# Addendum

No. TWO Date: 12/13/10

Project: PHYSICAL EDUCATION FACILITIES  
FOR MARBURY HIGH SCHOOL  
FOR THE AUTAUGA COUNTY  
BOARD OF EDUCATION  
PRATTVILLE, ALABAMA

PROJECT NO. 10-166  
BC # 2010979

SD1

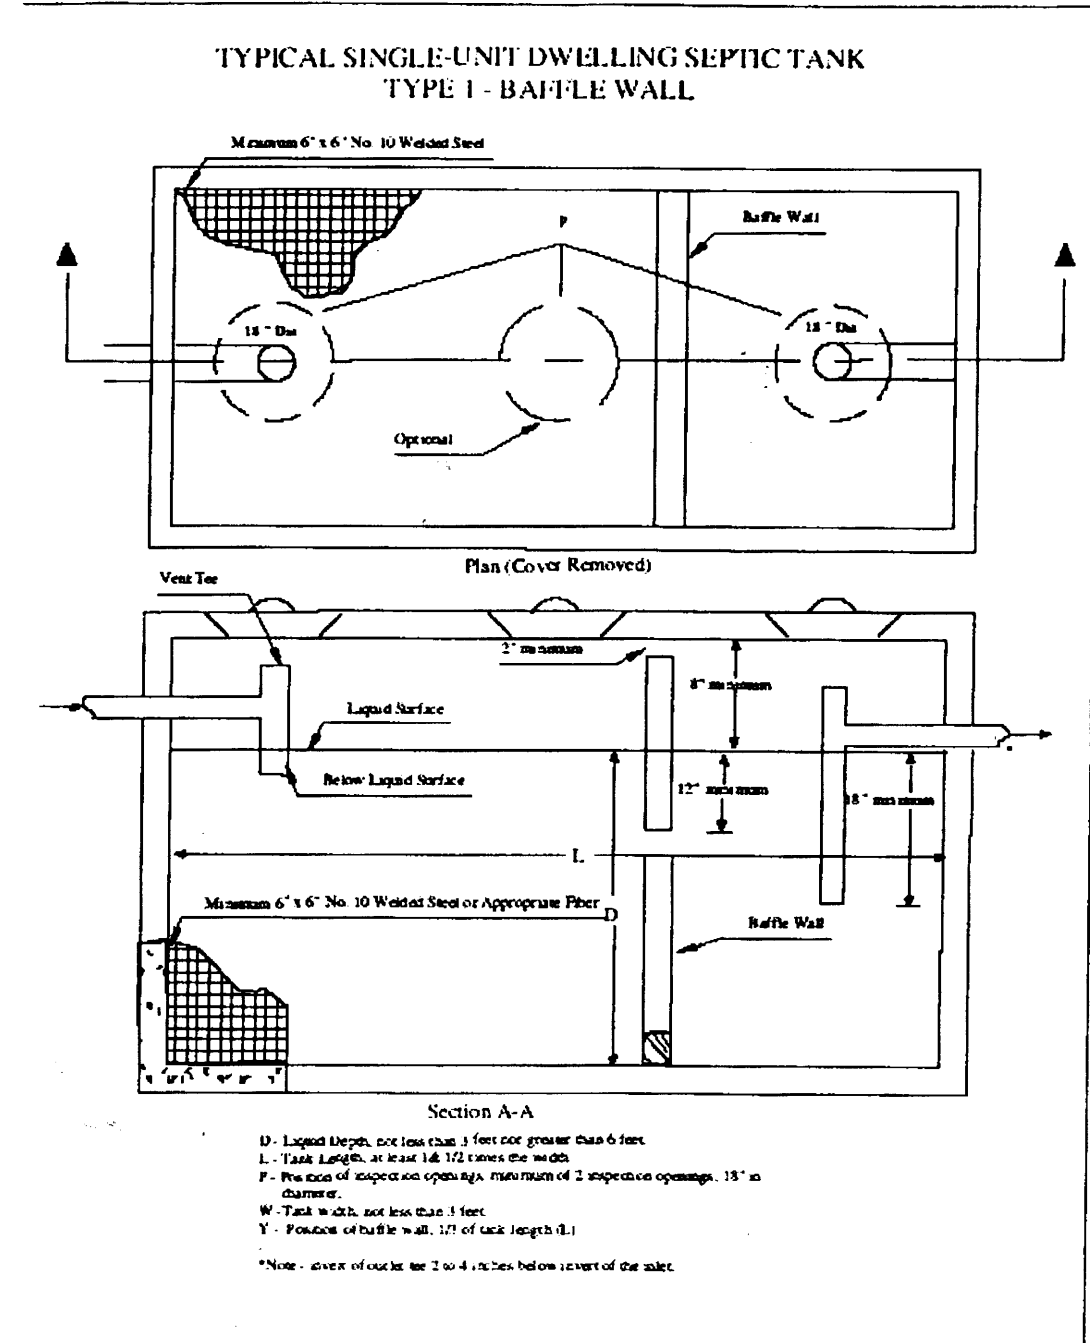
Add the following **Supplemental Drawings SD1, SD2 and Computations for Septic System.**
- D. The furnishing and installation of **Section 10350, Flagpoles**, shall be included in **Proposal “B” and Proposal “I”**.
- E. **Clarification:** Proposal “A” shall be responsible for the ADEM requirements as specified in Section 02100.
- F. The furnishing and installation of **Section 02720, Storm Sewers**, shall be included in **Proposal “A”**.

SD3

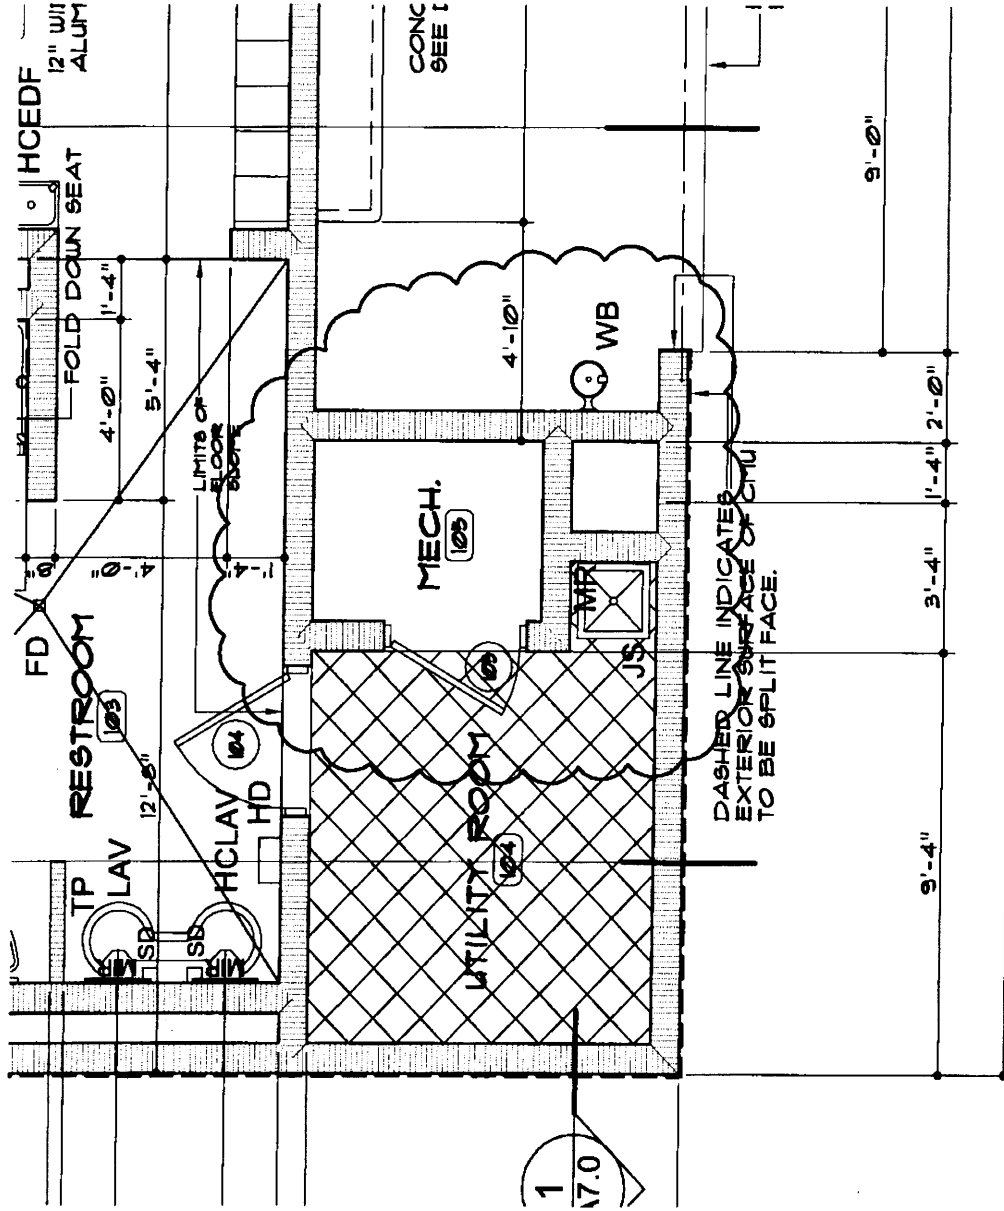
- A. See the attached **Supplemental Drawings SD3 and SD4** for revisions to Sheet A-3.0.
- B. See the attached letter (dated Dec. 13, 2010) and **Supplemental Drawings SD5, SD6 and SD7** from Gunn and Associates regarding changes to the Sheet E2.2 and E4.1.

**SD5**

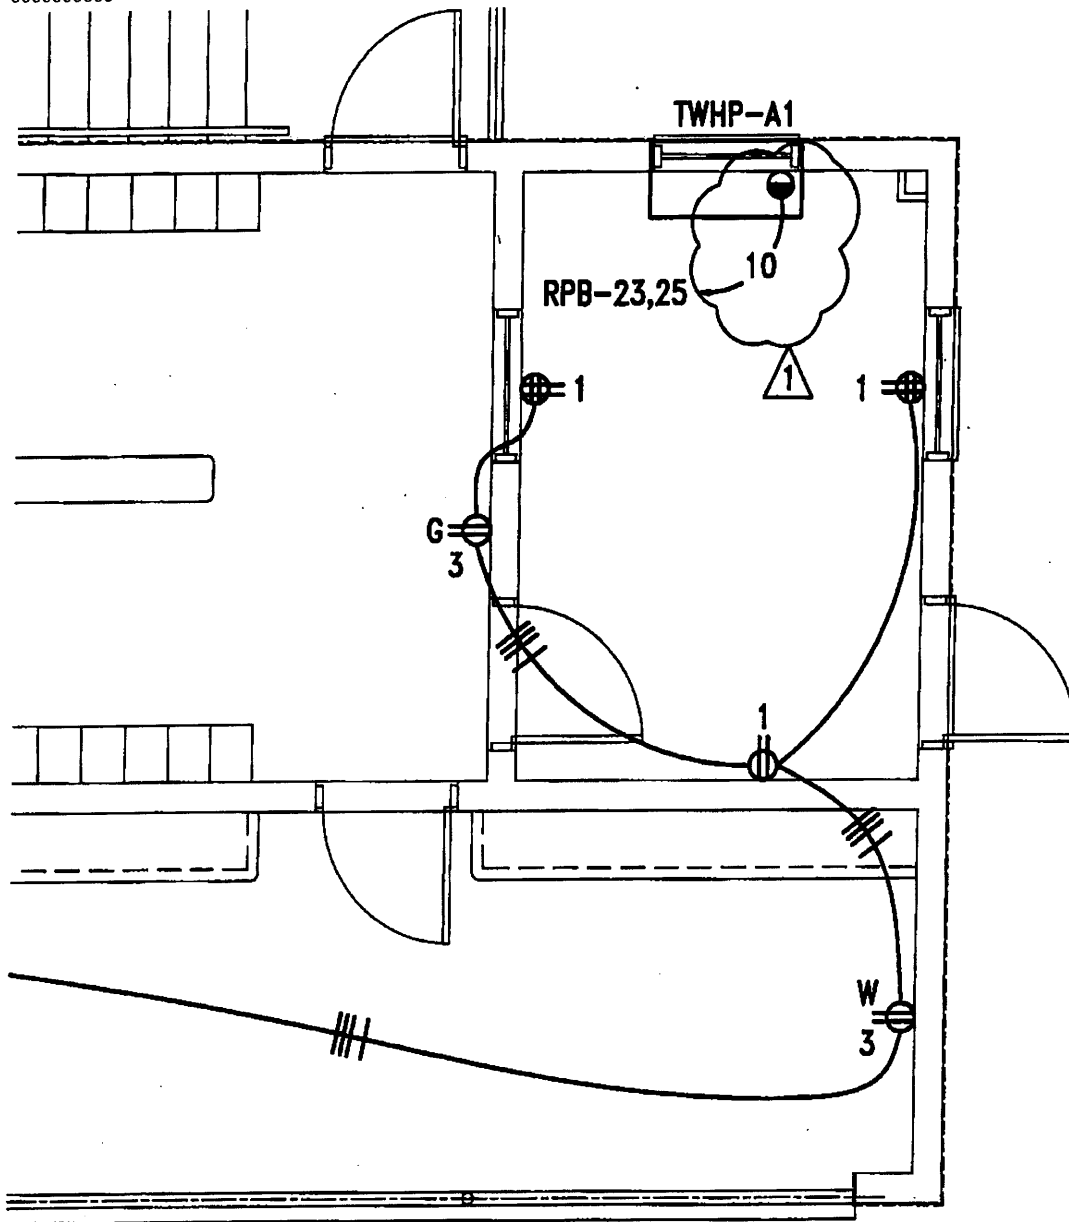
1. SHEET E2.2:
  - A. The branch circuit homerun for both mechanical units OF-1A and OF-1B shall be fed with 2#8 & 1#10 GRD – 1°C.
  - B. The branch circuit homerun for both mechanical units TWHP-A1 and TWHP-A2 shall be fed with 2#10 & 1#10 GRD – 3/4°C.

SD7

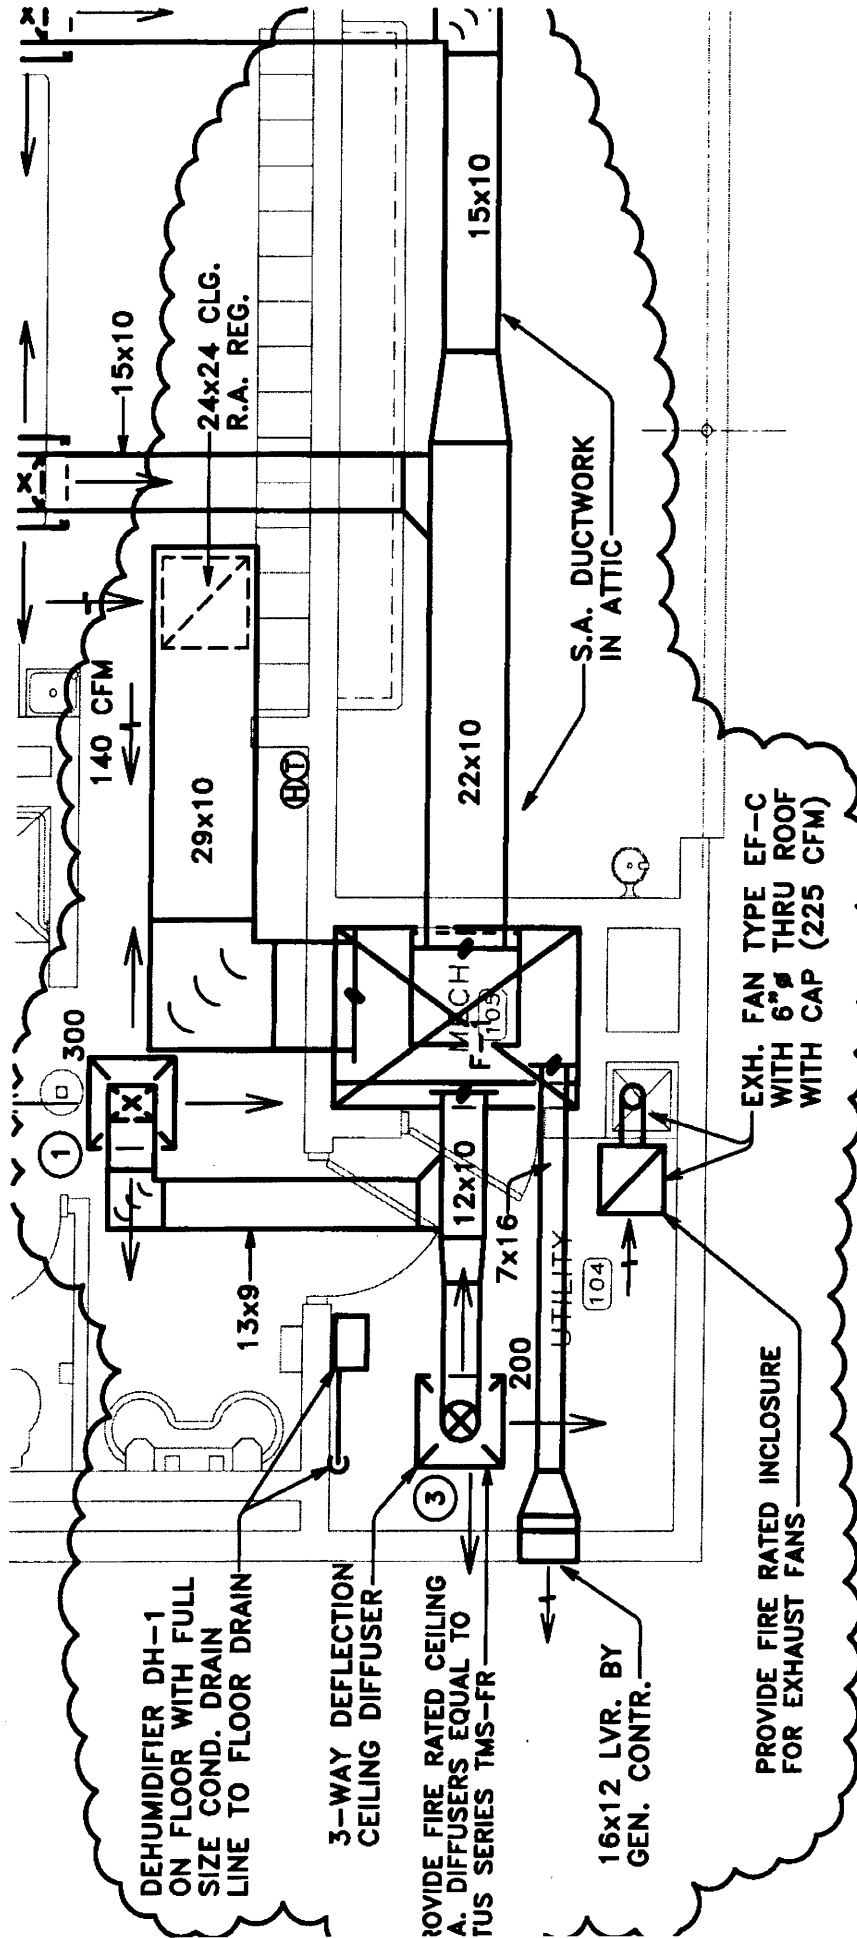
2. SHEET E4.1:
  - A. The secondary feeder from transformer T-B to panel RPS shall be fed with 4#250KCM & 1#2 GRD – 3°C.

**SD8**

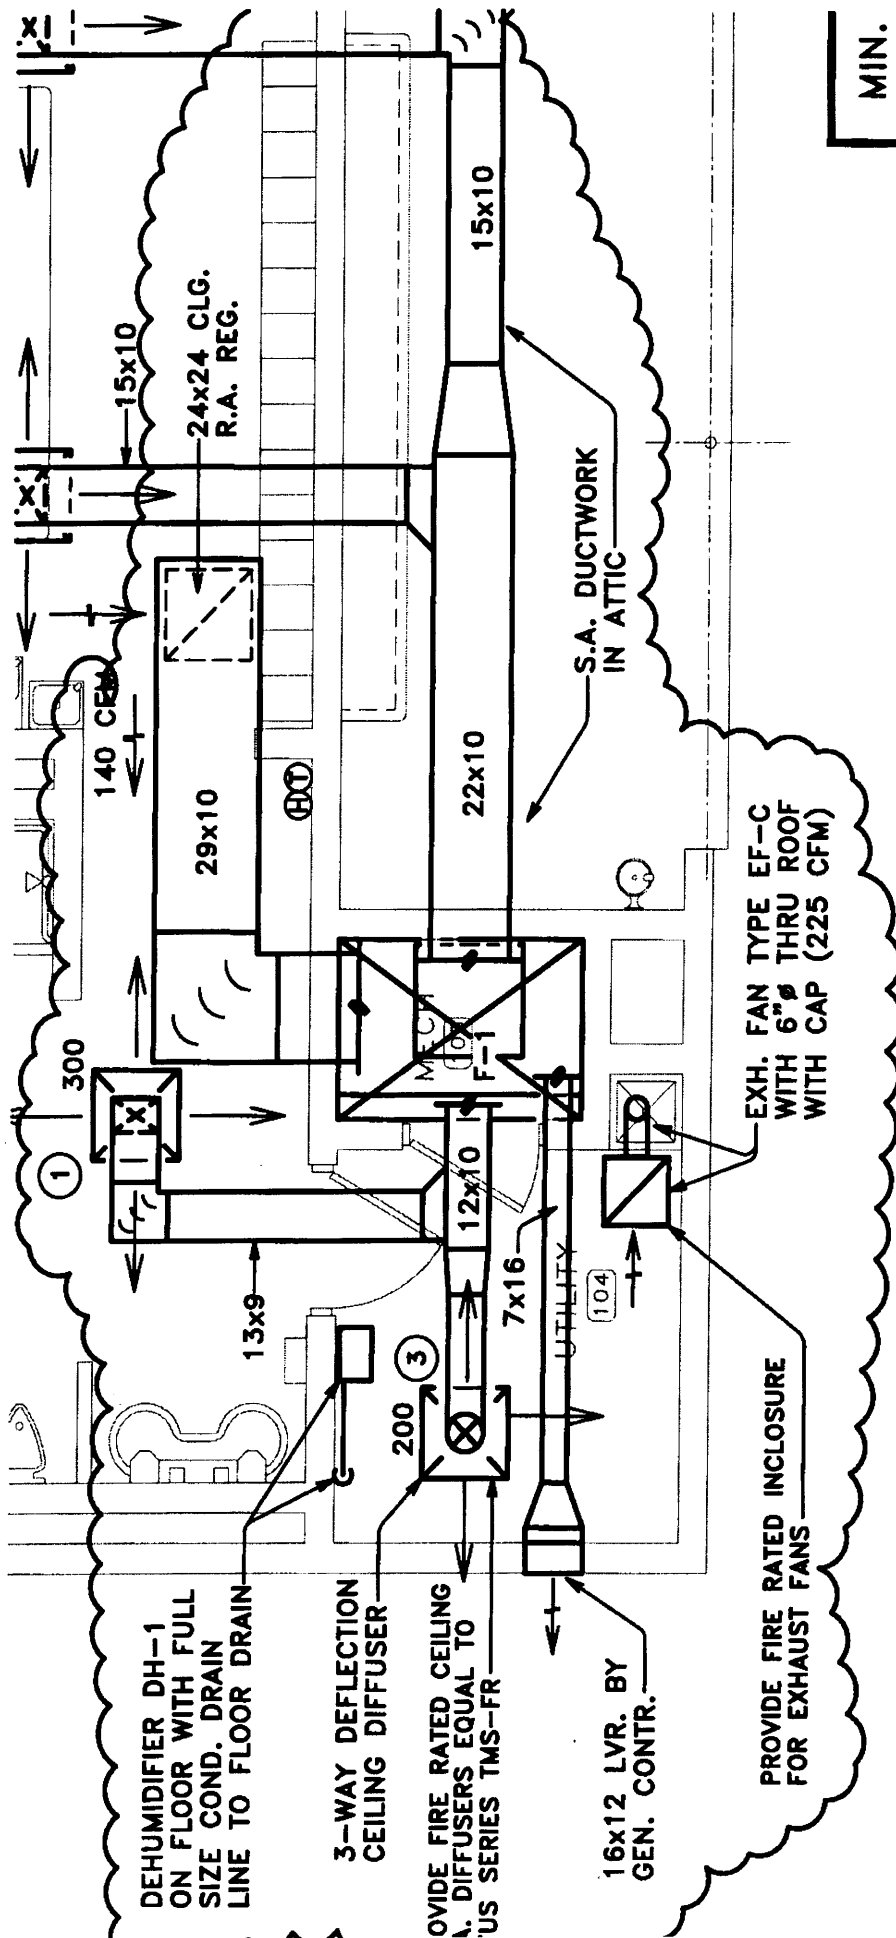
- C. Refer to **Sheet M-1**: See the attached **Supplemental Drawings SD8, SD9, SD10 and SD11** for revisions.
- D. Refer to **Sheet P-1**: See the attached **Supplemental Drawings SD12 and SD13** for revisions.

DEHUMIDIFIER DH-1  
ON FLOOR WITH FULL  
SIZE COND. DRAIN  
LINE TO FLOOR DRAIN

PROVIDE FIRE RATED CEILING  
A. DIFFUSERS EQUAL TO  
TMS SERIES TMS-FR

PROVIDE FIRE RATED ENCLOSURE  
FOR EXHAUST FANS

EXH. FAN TYPE EF-C  
WITH 6" THRU ROOF  
WITH CAP (225 CFM)
